BIDDING AND CONTRACT DOCUMENTS ADDENDUM NUMBER ONE STATE PROJECT NO. 17-054A-1

May 2, 2018

WAYNESVILLE-ST. ROBERT REGIONAL AIRPORT

CONSTRUCT PARALEL TAXIWAY, WIND CONE & FUEL ACCESS ROAD

> FENCE DETAILS SHEET 1 OF 2

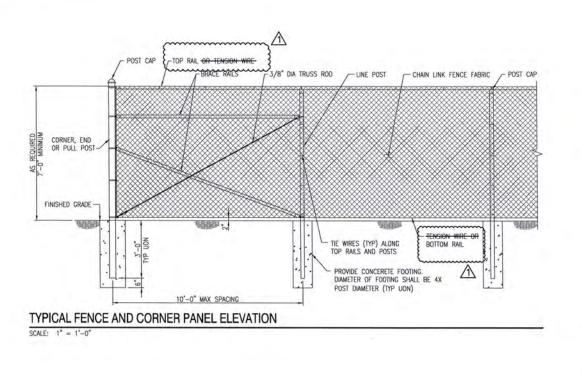
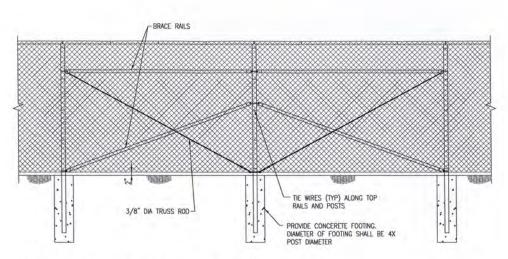
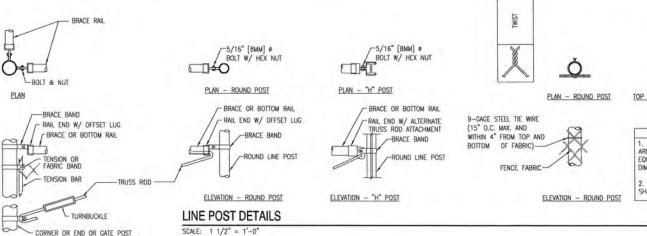
NOTE (1): A BOTTOM RAIL CAN BE ADDED FOR SECURITY, IT SHALL BE INSTALLED APPROX 3" ABOVE GRADE (A MINIMUM OF 2" AND A MAXIMUM OF 4"). HARDWARE SHALL BE WELDED OR SHOT NAILED TO POSTS AND RAILS IN ORDER TO SECURE IN PLACE, ATTACH FABRIC TO NEW BOTTOM RAIL TO ELIMINATE

- 4. Underdrains will be 6" per the pay item and specifications.
- 5. Only Tree stumps can be incinerated. Trees and brush can not be burned
- 6. Top and bottom rails are required on the fence.
- 7. Pull Posts will be installed at every corner and at gates per the fence and gate detail sheets.
- 8. The Bidder's Statement of Qualifications must be turned in within 48 hours after bid opening.
